SAFENIGHT TECHNOLOGY INC.

May 21, 1996

Re: Response to 5/3 deficiency call

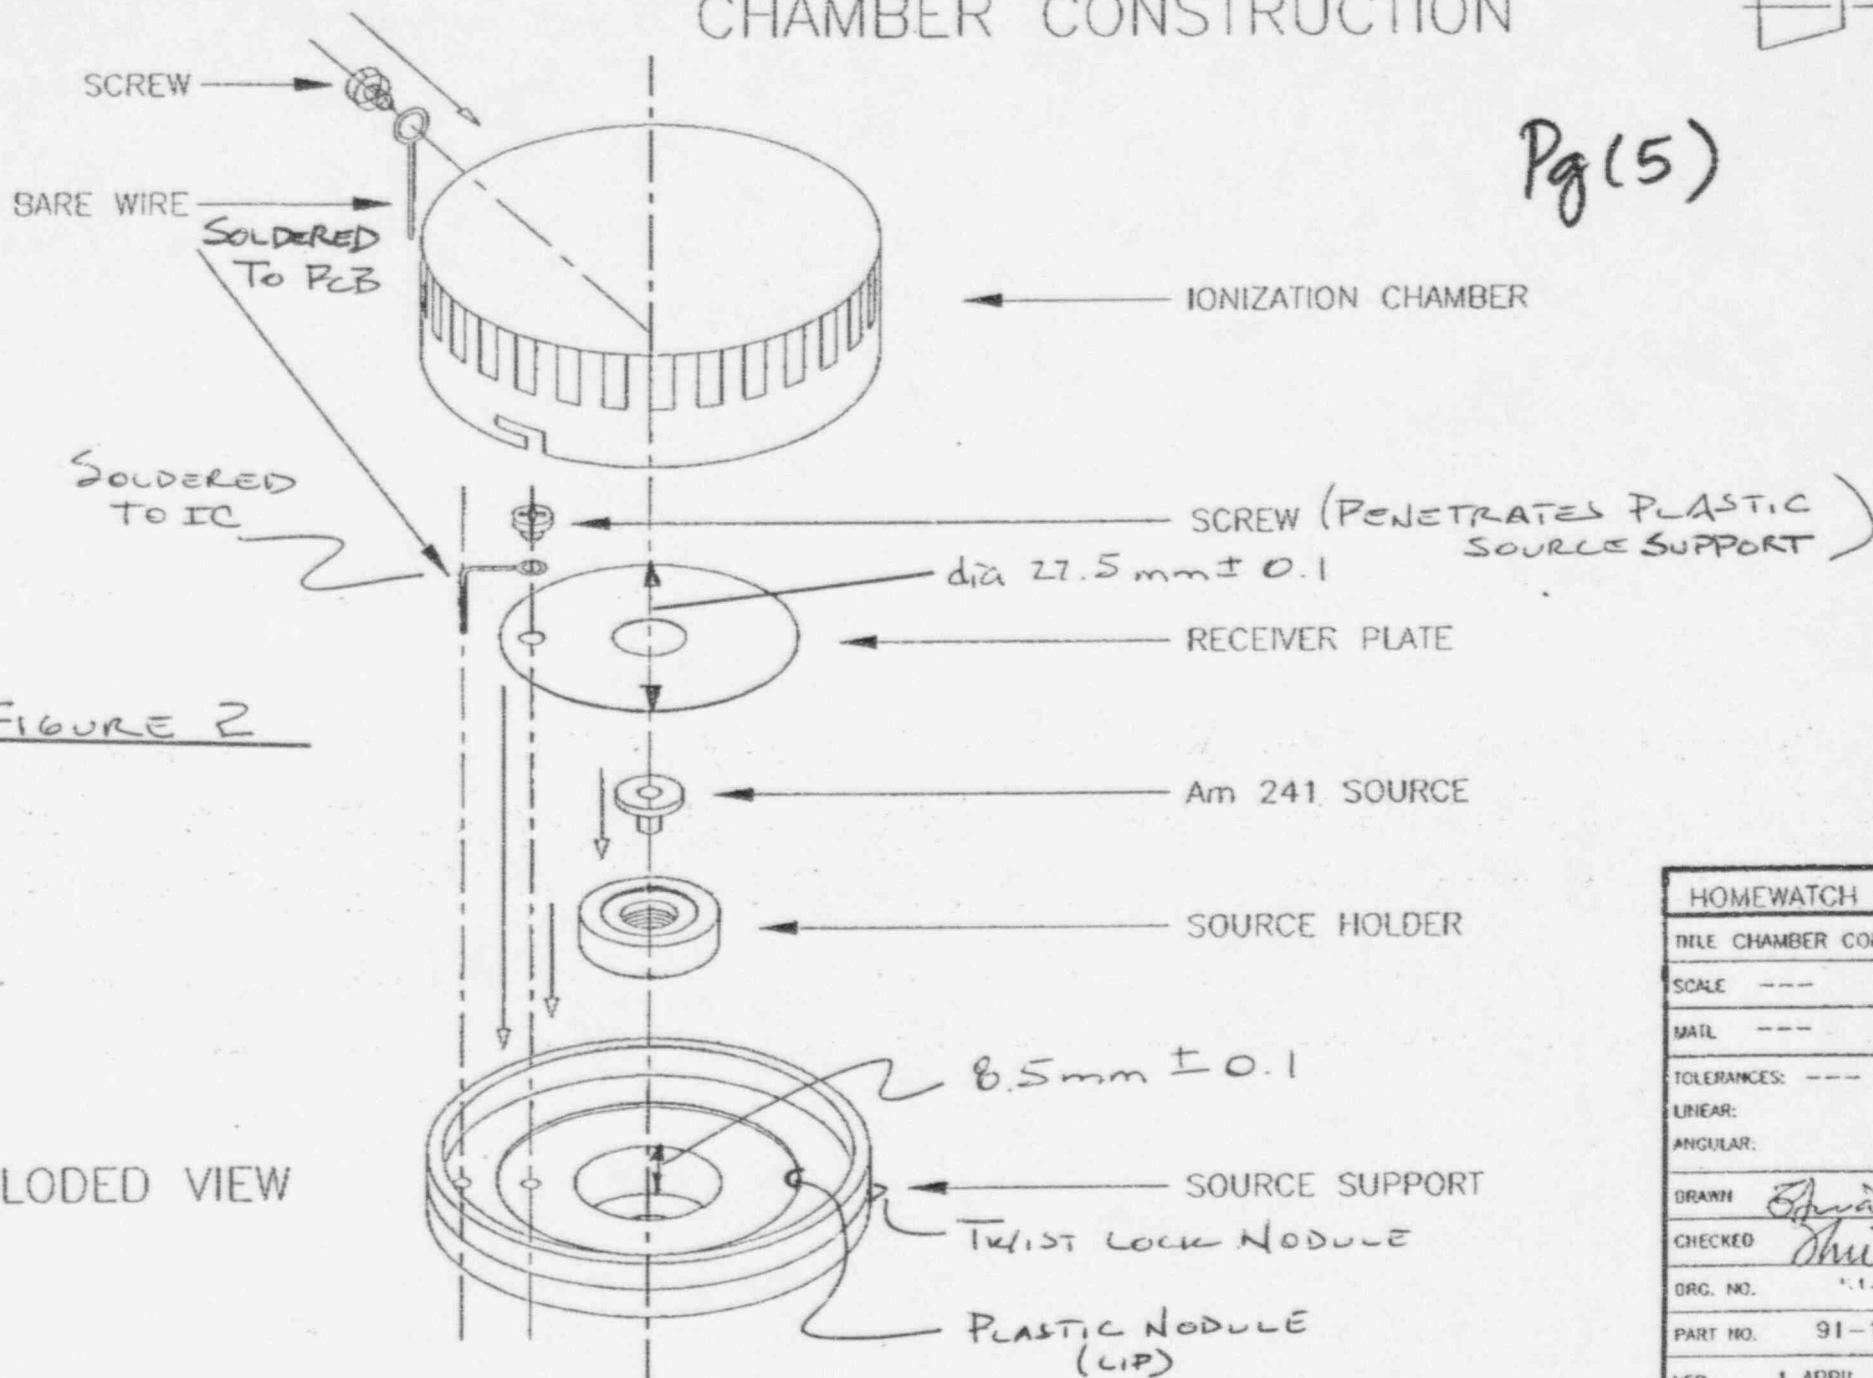
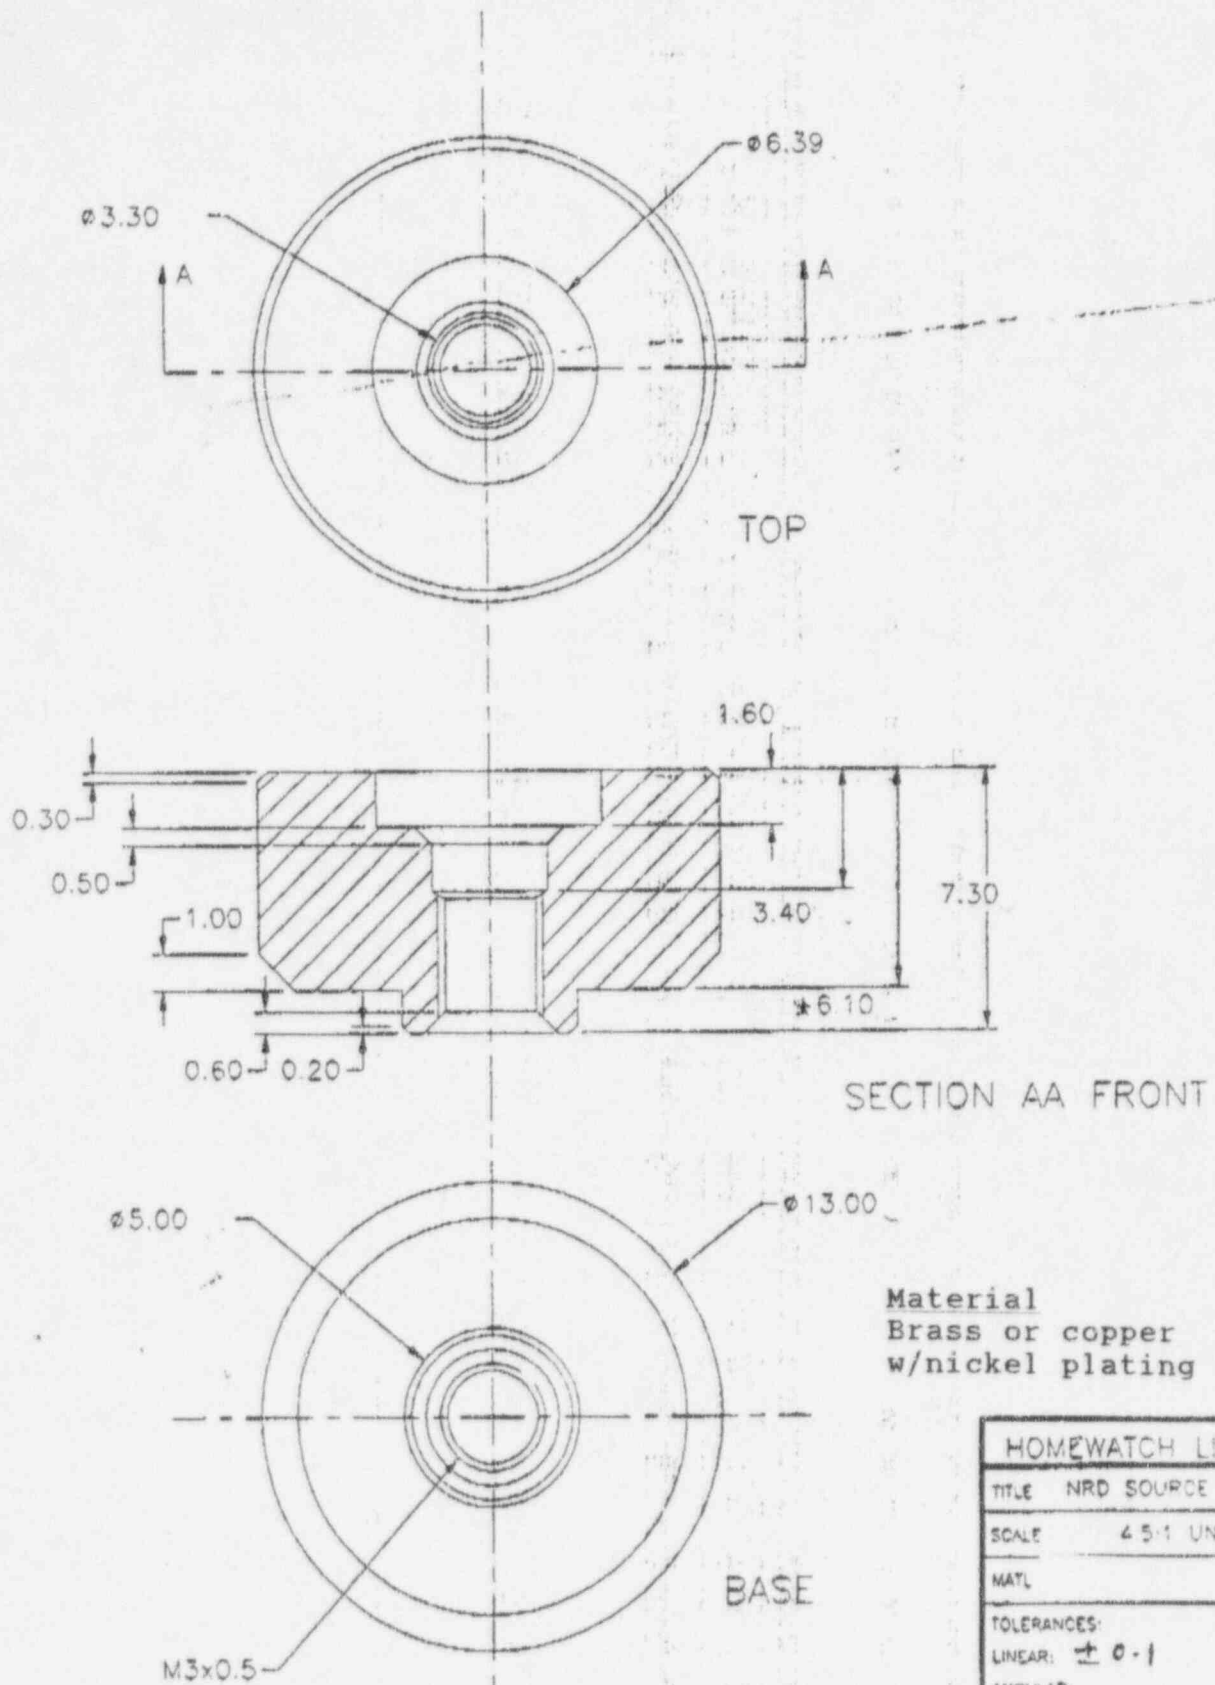
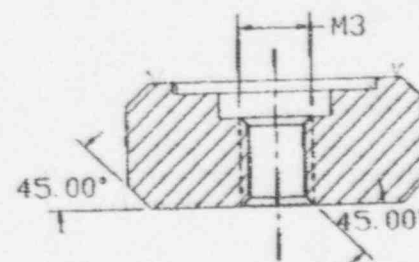
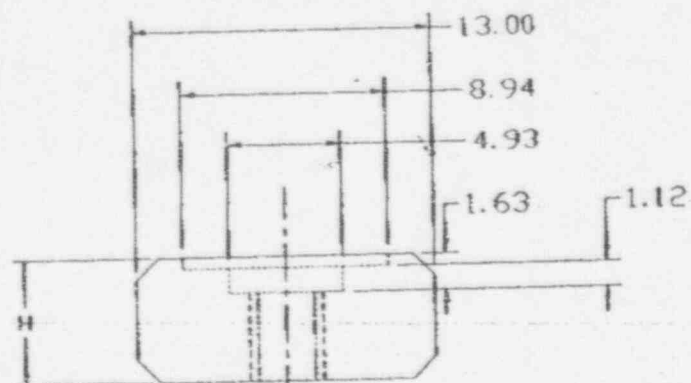
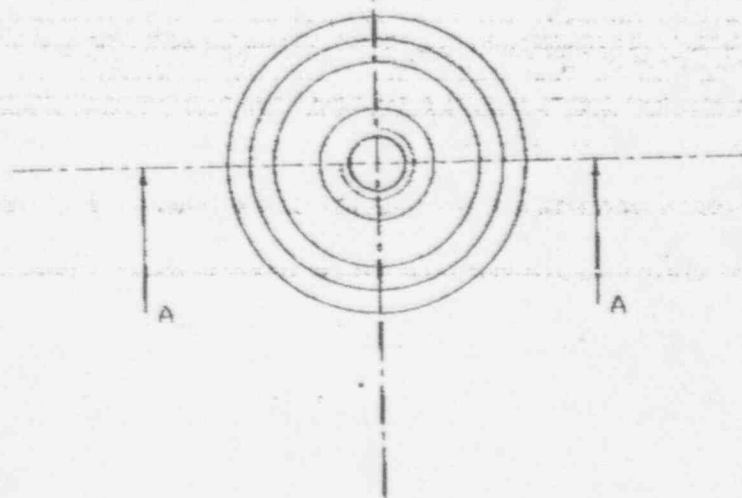
5. There are several apparent contradictions in the drawings and descriptions submitted. For example, the ion chamber cover is described as steel/tin in section 3.2.1 of your application and is described as steel/tin or steel/copper or steel/nickel on one of the drawings. Another example is that the Homewatch source holder is listed as nickel plated copper in one place and nickel plated brass on one of the drawings. There were also discrepancies in the dimensions listed. For example, section 3.3.2 4(a) states that the diameter of the housing is 5+/-2 inches, which results in a range of 3-7 inches. In contrast, the drawing of the PCB layout lists the larger dimension of the PCB as 5+/-1 inches, which results in range of 4-6 inches. This range does not allow for a circuit board that would fit in the smallest requested diameter of the housing. Another example is section 3.3.2 states that the height of the cover is 2+/-1 inches, which results in a range of 1-3 inches. Based on measurements submitted for the ion chamber, the apparent height of the ion chamber is 1.01 inches, which would not fit into the smallest requested cover height. In view of these and other apparent discrepancies, please review the information your drawings and descriptions, and resubmit complete and corrected information.

- 5) On page B17, #24g) 5% here refers to the submitted LTPD = 5% Table on page B32
- 6) On page B11, #9c, the contractor will be required to check 100% of the lot and correct them prior to its return to us.
- 7) Please accept substitution of new pages 3,4,5,6,7,10, 11, and 12. They should clear up conflicting data on old sheets.... materials, dimensions. They also add further dimensions to the HomeWatch Source Holders (for Amersham and NRD). One modification was added.... p.11, snap-lock and screwed covers were added as possible options. Since our prototype testing has been on PCB without a plastic case, these have no worse impact on "device" integrity.
- 8) On the chamber drawings, M3 designates a metric screw/ opening size
- 9) Our January 31st letter contained a typographical error. The "and" between MICROCURIE and U.S. should not be there.
